FEDERAL ENERGY REGULATORY COMMISSION
Washington, D. C. 20426

Project No. 3142-007
Barton Dam Project
City of Ann Arbor

Subject: Run-of-River Deviations

Outflow/Pond Level- December

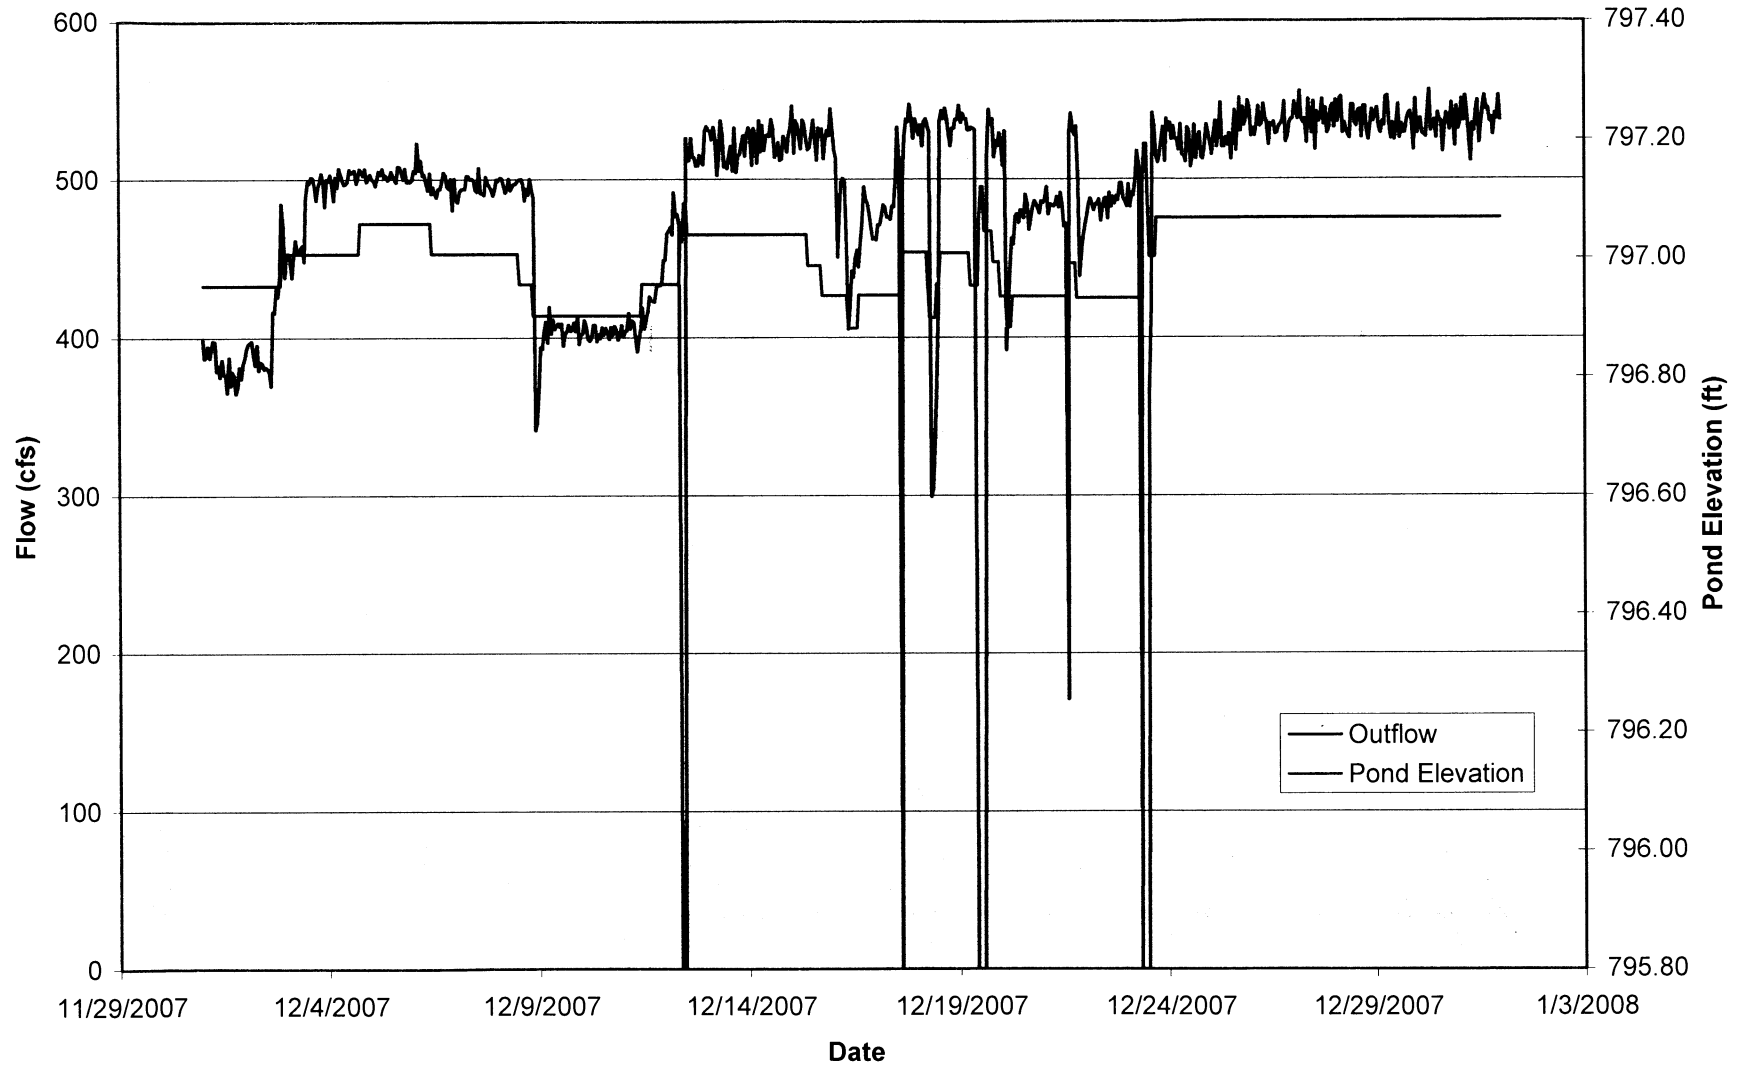
Since gaging stations were not installed at the project, as required by the FWS's article 2 terms and conditions letter, we used the available hourly generation records and the turbine flow rating table provided to determine equivalent flow estimates per hourly generation values. In reviewing this information, we identified specific dates and times when project discharges fluctuated significantly over short periods of time. Specifically, we identified run-of-river deviations on December 8, 18, 20, and 21, 2007; January 2, 4, 6, 10, 16,

30, and 31, 2008; and February 3, 4, 6, 8, and 14, 2008. Appendix A of this letter includes tables and graphs providing more details about these run-of-river deviations.

In order to resolve the problem, we request that you file a run-of-river plan within 120 days of the date of this letter. The plan should be developed in consultation with the MDNR and FWS. The plan should include provisions for the installation of gaging stations upstream and downstream of the project, pursuant to the FWS's terms and conditions, or concurrence from the FWS on an acceptable alternative. The plan should also include a schedule for installing the gaging stations or alternative measures, and provisions for providing hourly flow records in cubic feet per second (cfs) to the Commission and agencies to verify compliance. In addition, your filing should include documentation of consultation with the MDNR and FWS on your proposed plan, including responses to any specific agency recommendations that are not incorporated into the plan. You should allow a minimum of 30 days for the entities to comment and to make recommendations before filing the plan with the Commission.
